PILATUS AIRCRAFT LTD. CH-6371 STANS, SWITZERLAND

**SUBJECT: P&WC SERVICE BULLETIN NUMBER PT6A-72-14254R1**

TURBOPROP ENGINE  
FUEL CONTROL UNIT - REPLACEMENT/MODIFICATION OF

ENGINE FUEL AND CONTROL - FUEL CONTROL ASSEMBLY -  
REPLACEMENT OF Py ORIFICE

Progression of the Part  
Figure 1

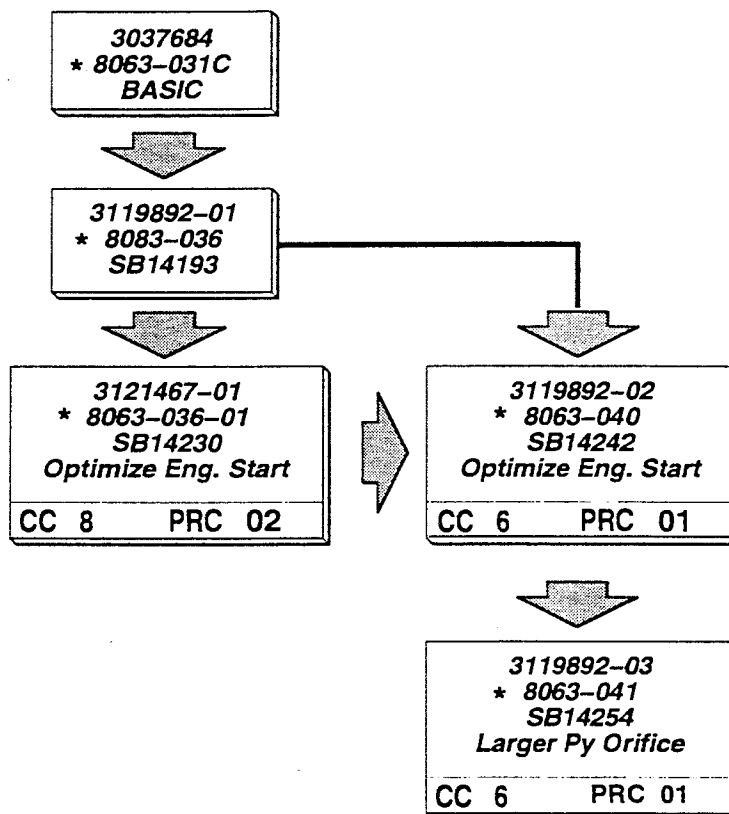
- (1) For engines incorporating P&WC S.B. No. 14242R1:
  - (a) Remove fuel control unit P/N 8063-040 (P&WC P/N 3119892-02)
  - (b) Install new or modified fuel control unit P/N 8063-041 (P&WC P/N 3119892-03).
  - (c) Write "P&WC S.B. No. 14254 Incorporated" in the engine log book.
- (2) For engines not incorporating P&WC S.B. No. 14242R1:

- (a) Remove fuel control unit P/N 8063-036 (P&WC P/N 3119892-01) or P/N 8063-036-01 (P&WC P/N 3121467-01).
- (b) Install new or modified fuel control unit P/N 8063-041 (P&WC P/N 3119892-03).
- (c) Write "P&WC S.B. No. 14254 Incorporated" in the engine log book.

A. Refer to Figure 1 for Parts Progression.

Model 8063-041

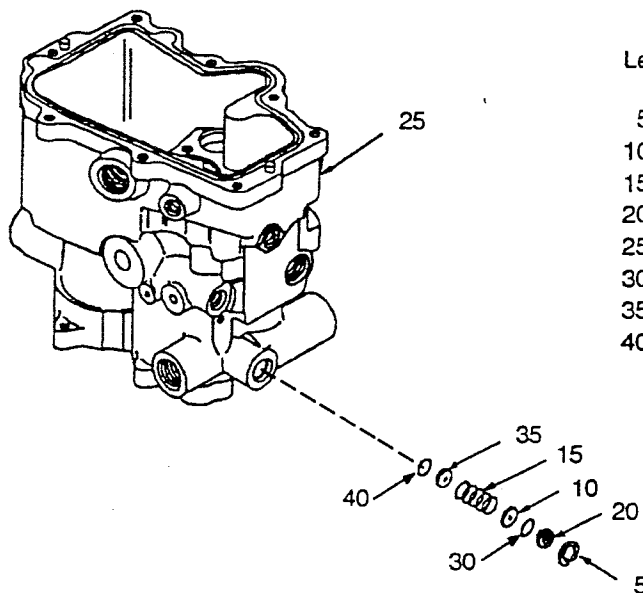
- (1) Units repaired at an overhaul facility, replace nameplate (P/N 3082-236). Copy Woodward serial number (omit P&WC P/N) from the old nameplate and stamp new nameplate (P/N 3082-236) prior to attachment (refer to REPAIR section of referenced manual for proper nameplate replacement), as follows:

- (2) Units repaired in the field may be identified by stamping or etching out old P&WC P/N and Woodward P/N and stamping or etching new P/N 8063-041.

Figure 1

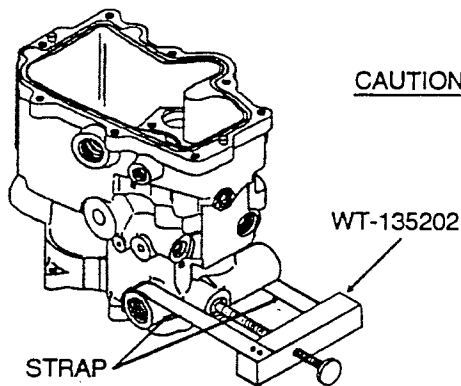
Replace the Py orifice plate in the FCU with one with a larger diameter orifice.

- (1) Using WT-135202, as shown in Figure 2, press on plate (10, Figure 1) until tension on ring (5) is relieved. Depress ring (20) and remove ring (5) from housing assembly (25). Slowly turn screw of WT-135202 until there is no tension on spring (15).
- (2) Remove ring (20), packing (30), plate (10), spring (15), orifice (35), and packing (40) from housing assembly (25).
- (3) Replace Py orifice P/N 3540-064 with P/N 3540-082.

- (1) Install WT-135202 on housing assembly (25) as shown in Figure 2.
- (2) Install packing (40, Figure 1) in bore of housing assembly (25).
- (3) Install orifice (35), with seat facing packing (40). Install spring (15) and plate (10) in housing assembly (25).
- (4) Install ring (5), ring (20), and packing (30) on WT-135202. Using WT-135202, compress spring (15) past the ring groove in housing assembly (25) and install packing (30), ring (20), and ring (5) in housing assembly (25).
